# Service Information

Category <b>P</b>	<b>Repair Guidance</b>	Ref. No. R021/14A	Page 1 of 3
Coverage <input type="checkbox"/> Distributor only <input checked="" type="checkbox"/> Please inform your dealers		Date Issued February 17, 2014	
Please convey this information to your <input type="checkbox"/> Director <input checked="" type="checkbox"/> General Manager <input checked="" type="checkbox"/> Warranty Dept. <input checked="" type="checkbox"/> Parts Dept. <input checked="" type="checkbox"/> Training Dept. <input checked="" type="checkbox"/> Field Rep.		Date Revised May 20, 2014	
Applicable Model CX-5(KE), Mazda6 (GJ) and Mazda3 (BM)		Applicable Countries or Specifications European Models

## Subject: Grinding Noise from Front Brake

### MASS PRODUCTION CHANGE

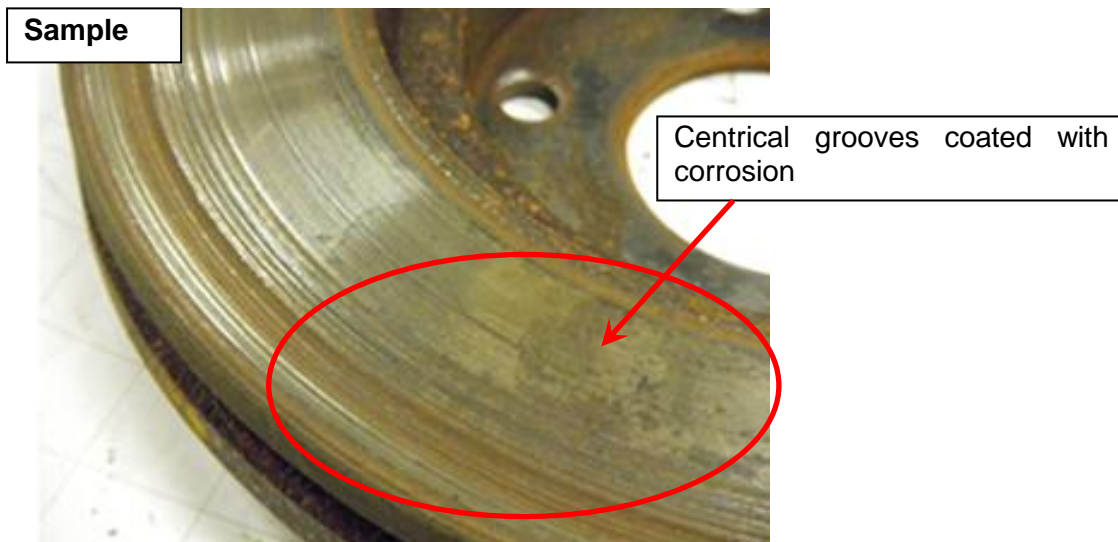
The shape of the front dust cover has been changed.
